SUBJECT: FAS 642 (CH 18)
Project ACHPP-HPP-ACSR-642(121)
Section 00-00127-00-WR
Coles County
Contract No. 95457
Item 122
April 25, 2008 Letting
Addendum (A)

Proposal – Revised Index of Special Provisions & Added Saw Cut Detail.

CH 18 RECONSTRUCTION @ IL RTE 121
SECTION: 00-00127-00-WR
COLES COUNTY, ILLINOIS

DETAIL OF SAWED CONTRACTION JOINT
8' SPACING 5 1/2" PCC C.H. 18

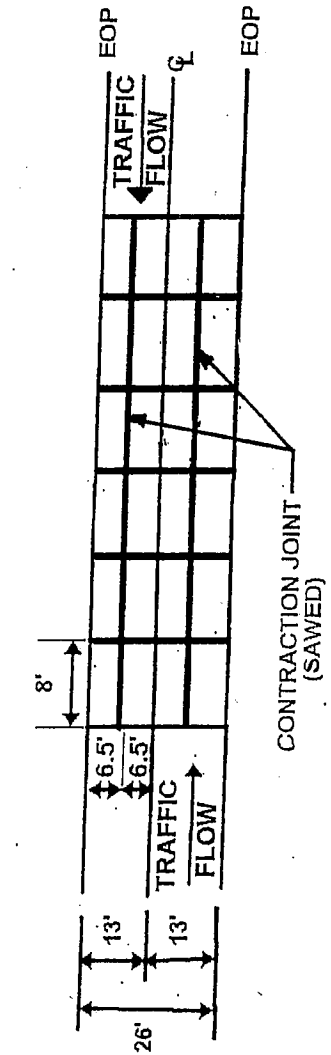
ADDENDUM 4-10-08
 SAW CUTS:
 LONGITUDINAL CENTER OF EACH LANE
 AND PERPENDICULAR TO CL ACROSS
 PAVEMENT EVERY 8'

LOCATION:
 C.H. 18 STA. 46 + 00 ~ 120 + 00

THIS WORK WILL BE INCLUDED IN THE CONTRACT UNIT PRICE PER SQUARE YARD FOR PORTLAND CEMENT CONCRETE OVERLAY 5 1/2" WHICH SHALL INCLUDE ALL LABOR AND MATERIAL AS SPECIFIED.
